DATE MAILED: 12/02/2005

Office Action Summary	Application No. 10/808,967	Applicant(s) NIWA ET AL.	
	Examiner Lan Nguyen	Art Unit 3683

Title: ANTI-SQUEAL SHIM STRUCTURE AND A DISC
BRAKE APPARATUS COMPRISING THE SAME
Inventor(s): Takahiro NIWA, et al.
Serial No.: 10/808 967
Docket No.: 4218.P0001US

Replacement Sheet

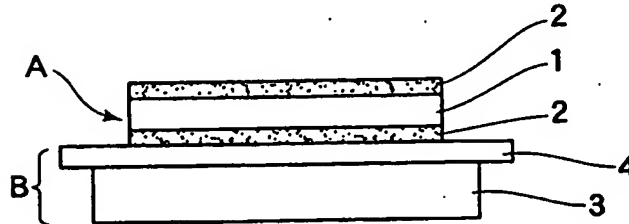
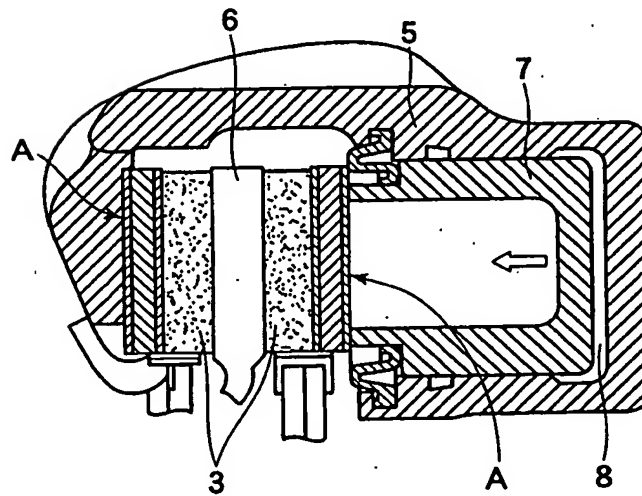
1. The drawings were received on 9/12/05. These drawings are approved.

approved
XLN
11/25/05
